ROSETTA PLASMA CONSORTIUM LANGMUIR PROBE

RPC LAP

RPC LAP Data Sets

ro-a-rpclap-2-ast2-edited-v1.0/data
ro-a-rpclap-3-ast2-calib-v1.0/data
R/C EB 1/2 8B Science Data

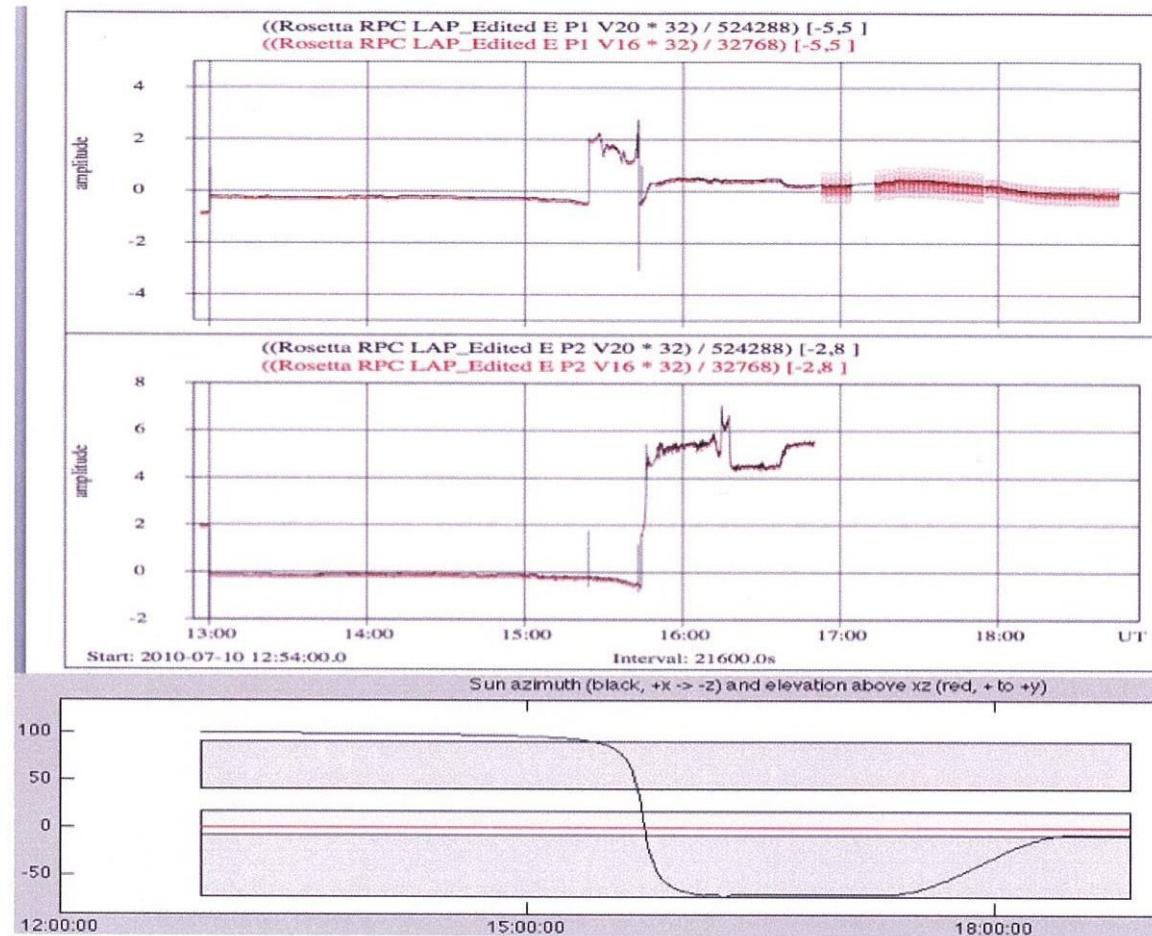
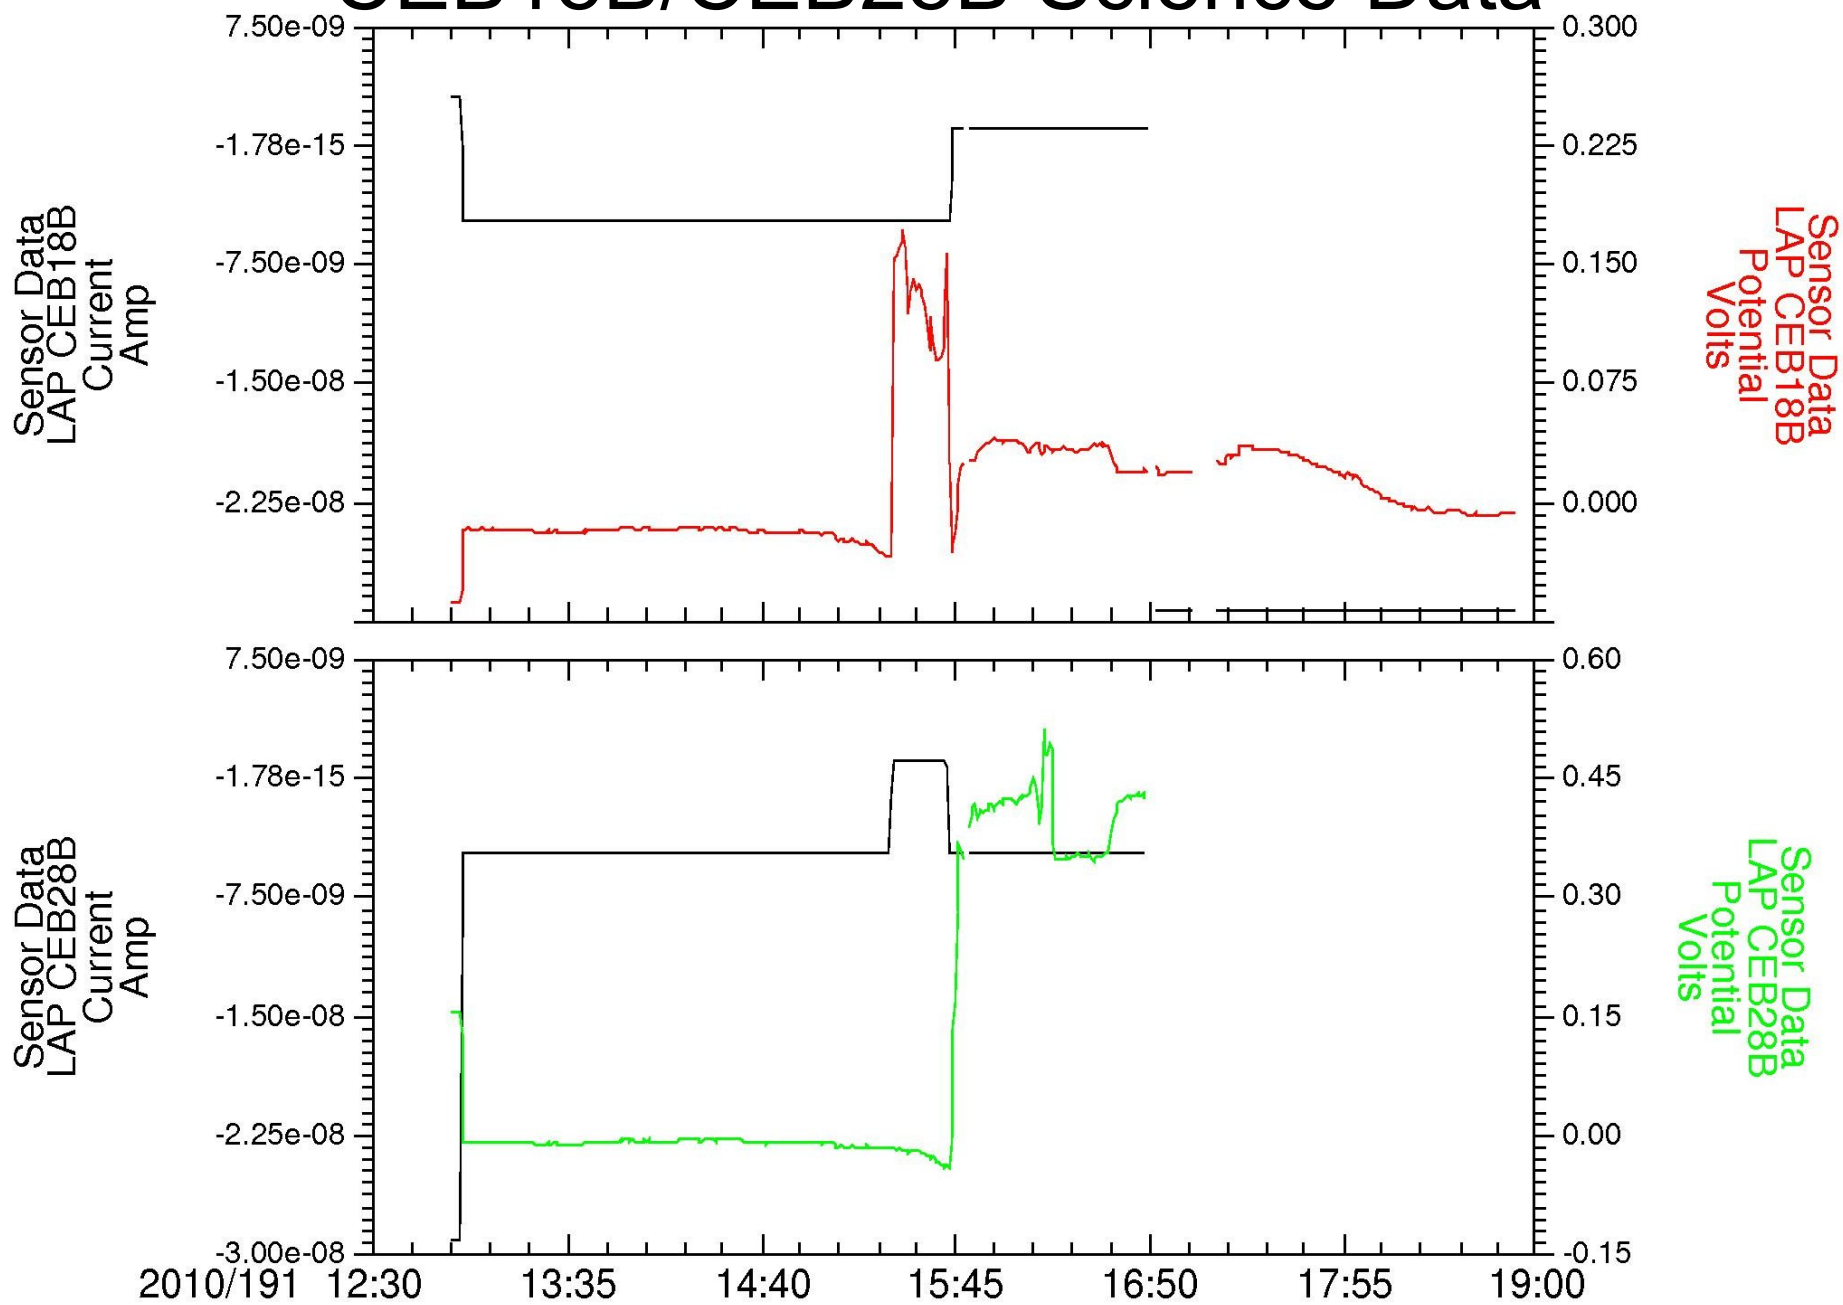
- ▶ Both edited and calibrated science data were examined and they both replicate the shape of the voltage as shown in the flight report.
- ▶ Amplitude voltage numbers of the flight report do not agree with the edited data, but do agree with the calibrated.
- ▶ It is not clear why the edited currents do not replicate the shape of the calibrated currents. The flight report does not seem to contain this information.

ro-a-rpclap-2-ast2-edited-v1.0/data
ro-a-rpclap-3-ast2-calib-v1.0/data
R/C DS 1/2 8B Science Data

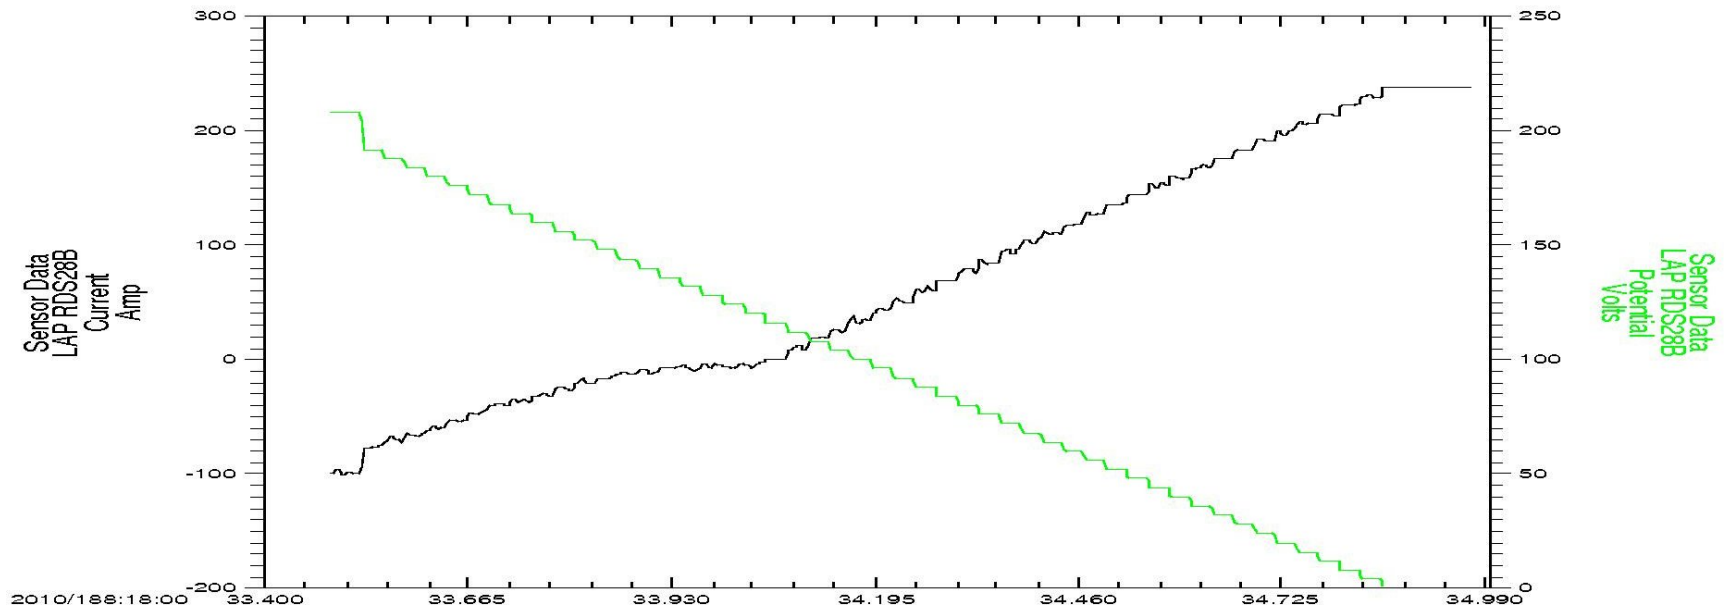
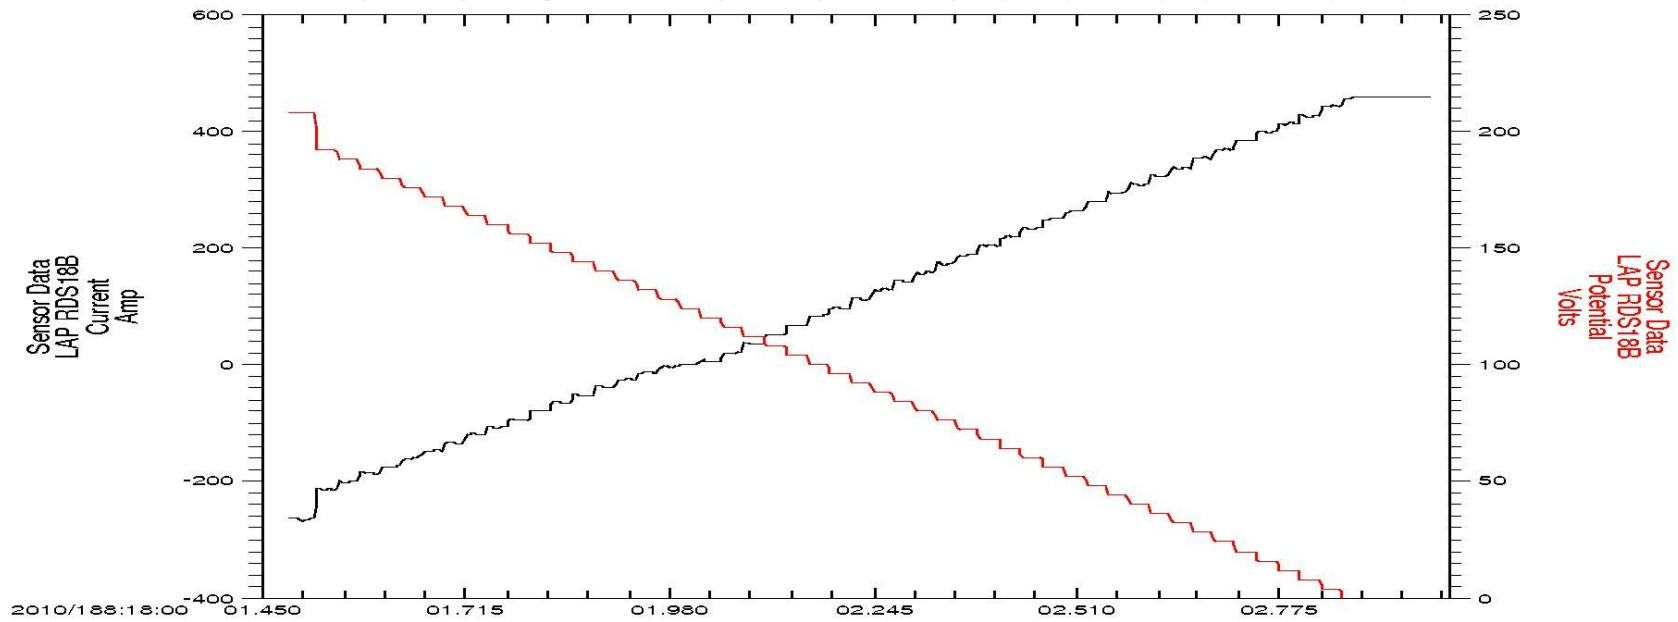
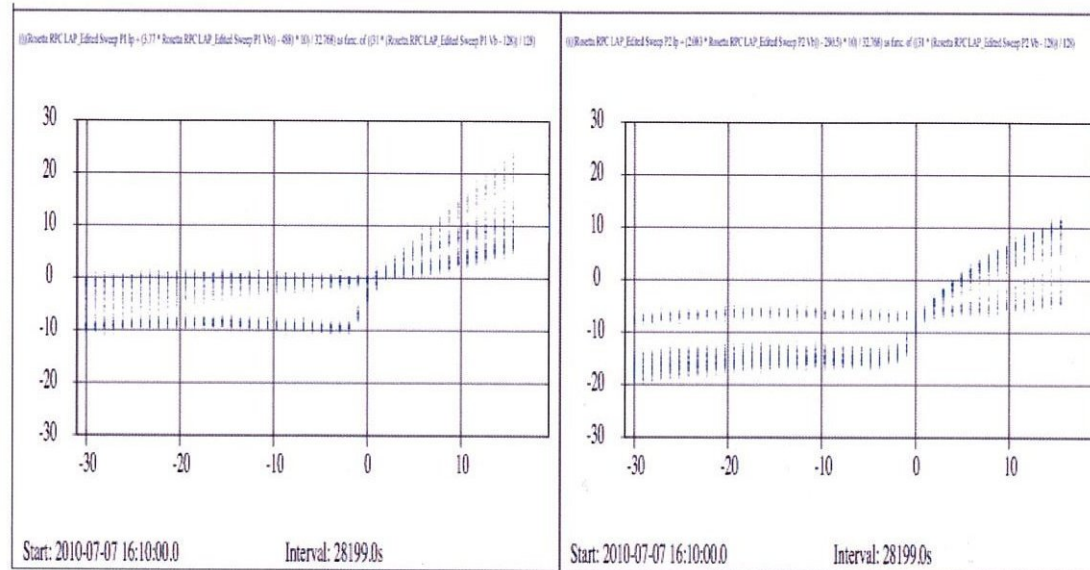
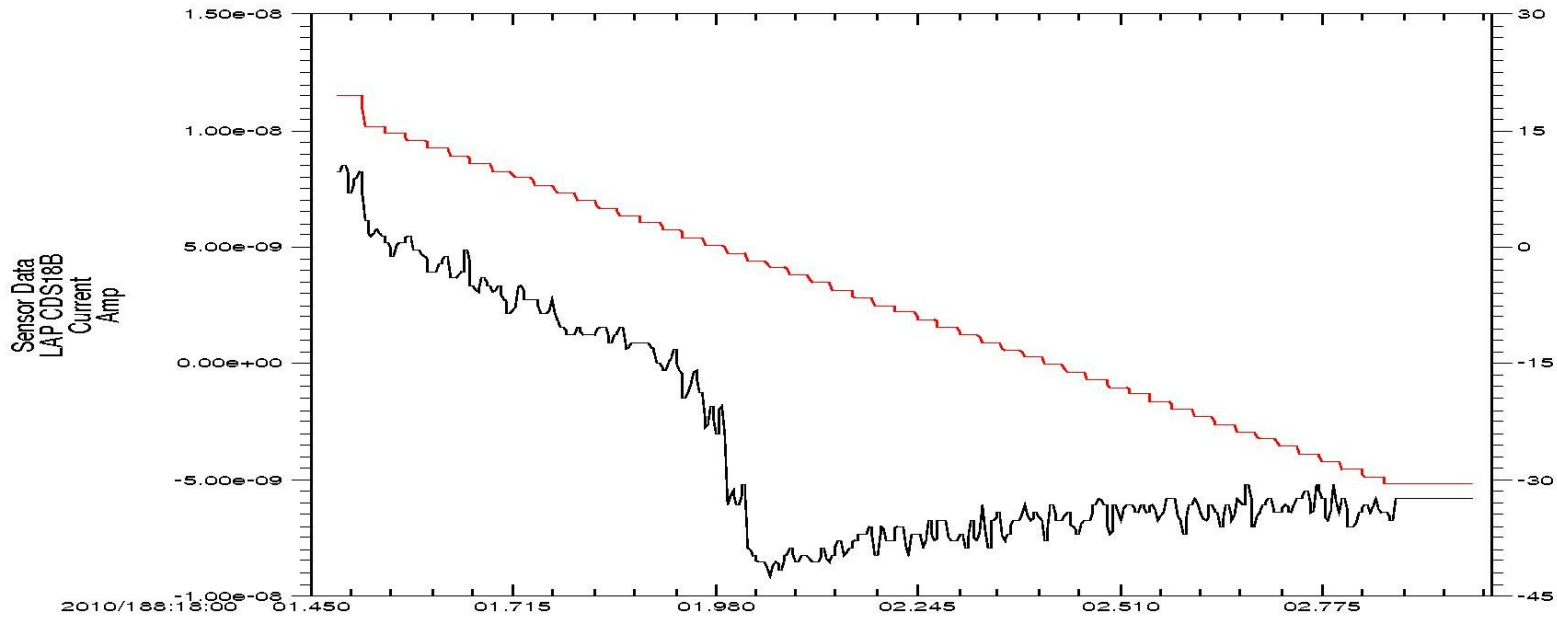
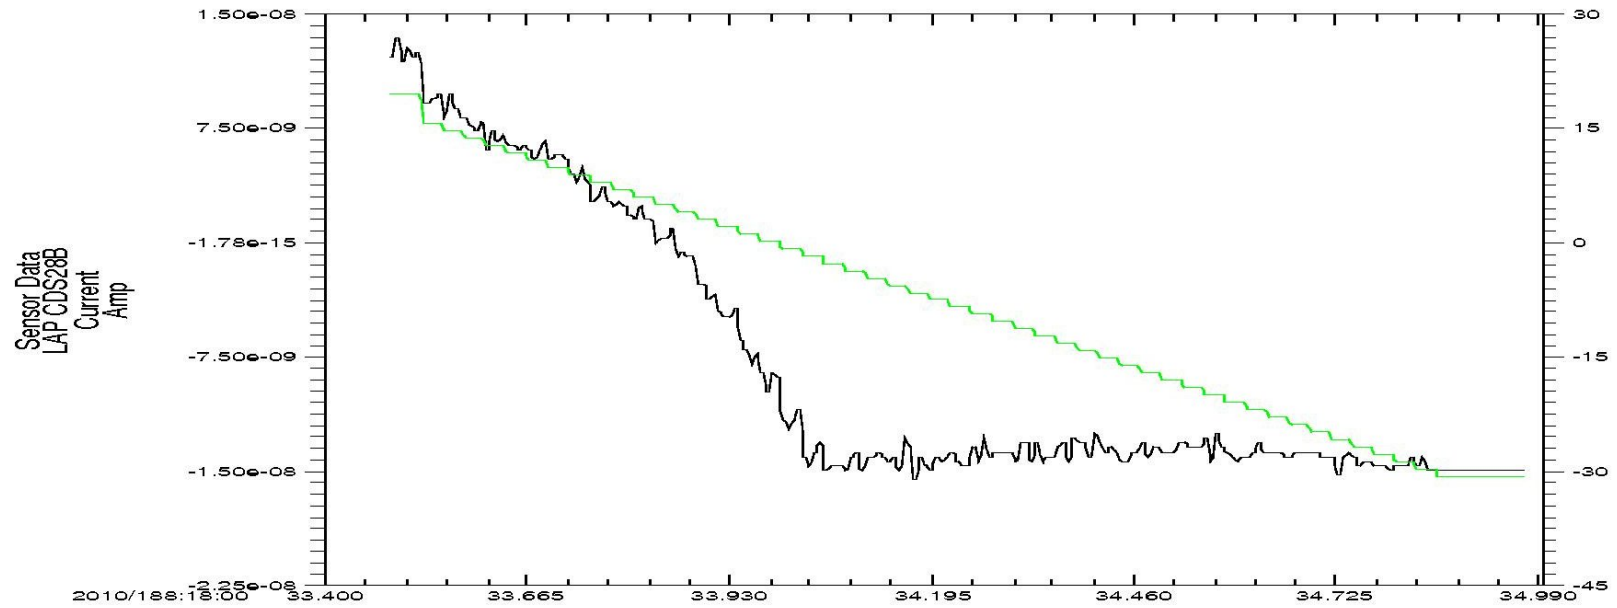
- ▶ Both edited and calibrated science data were examined and they both replicate the gross shape of the I-V curves as shown in the flight report.
- ▶ Amplitude voltage numbers of the flight report do not agree with the edited data, but are closer to the calibrated scales.
- ▶ It is not clear why the calibrated P2 current rises at large negative voltages (P1 due to contamination). They were expected to be flat or slightly negative slope. Please check this!
